IEEE P802.3dj interim meeting, September 16-19, 2024

Clarifications on Transmitter Constellation Closure (TCC) and Extended TCC (ETCC) as the Transmitter Quality Metric (TQM) for Coherent Transmitters in correspondence to Comment #259

Qirui Fan and Xiang Liu

The essence of the extended TCC (ETCC) approach (1)

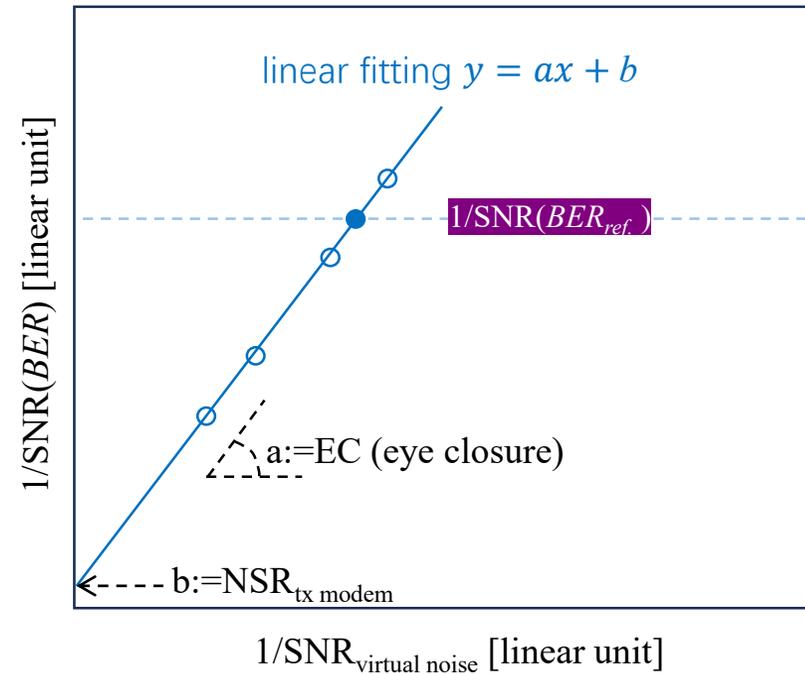
Comments on this approach:

- One can do fitting in the 1st step to extract required $\text{SNR}_{\text{virtual noise}}$, so the 2nd step becomes unnecessary for pure TQM.
- The EC here is referred to as Eye Closure, but it actually reflects noise enhancement and many other factors. It is unlike C_{eq} in TDECQ, which is only determined by FFE frequency response. So, EC here is not as well defined as C_{eq} in TDECQ.
- Therefore, the EC and $\text{NSR}_{\text{tx modem}}$ are at most informative terms, which only need to be specified optionally.

The essence of ETCC (2)

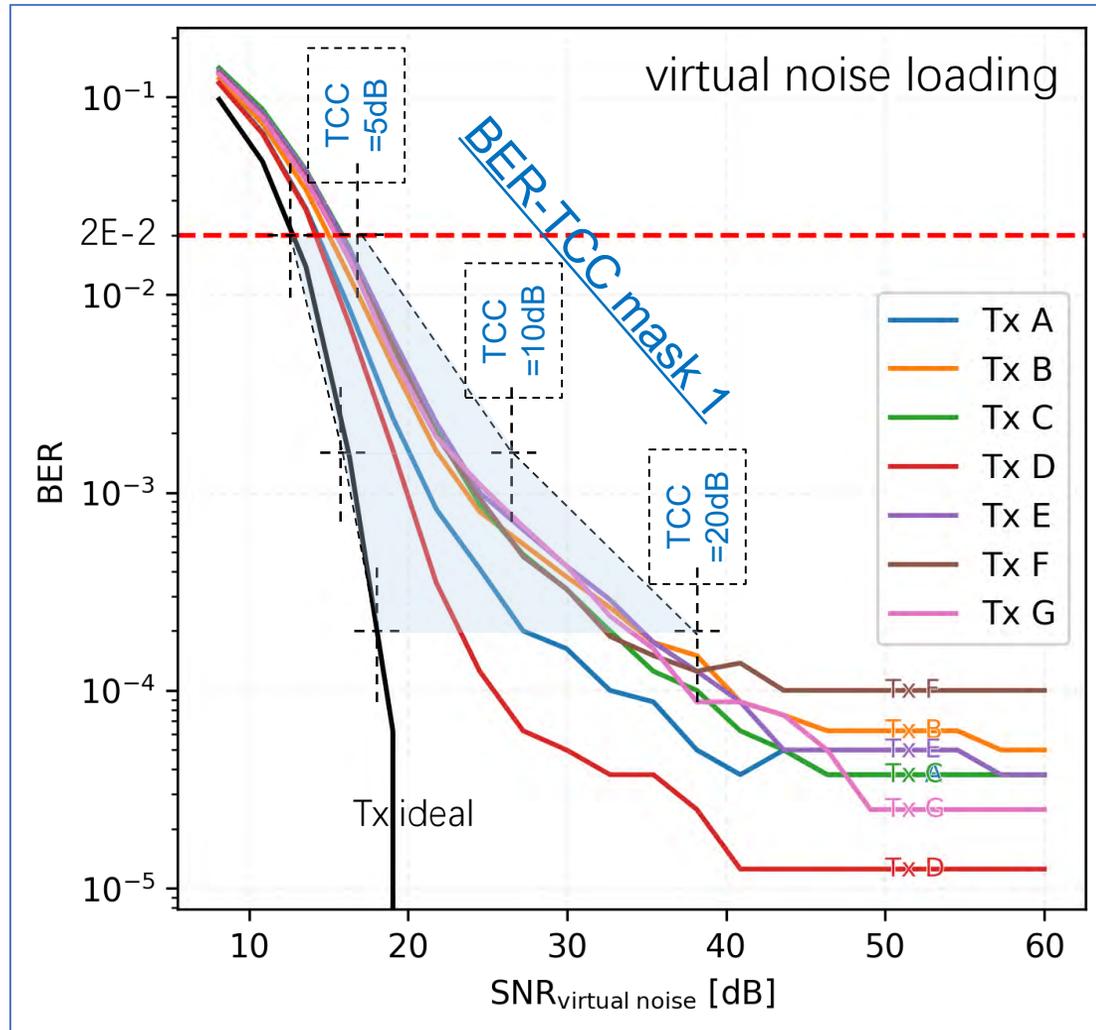
In [maniloff_3dj_02_2405](#), it was commented that TCC assumes $EC=1$. This is not true. In fact, the effect of noise enhancements are implicitly embedded in TCC calculation. Specifically, TCC measures the loaded noise power at the input of reference equalizer, so that the equalizer enhanced noises are functioning in the measurement loop.

The reasons for the ETCC approach to be referred to as extended TCC are:

1. Its 2-parameter fitting explicitly characterizes the linear regime of the BER waterfall curve, which provides an indication of the error floor behavior (which may be valuable to end users).
2. $SNR_{\text{virtual noise}@BER_{\text{ref}}}$ can be evaluated in extended ways. Besides noise searching, fitting or interpolation are also viable.
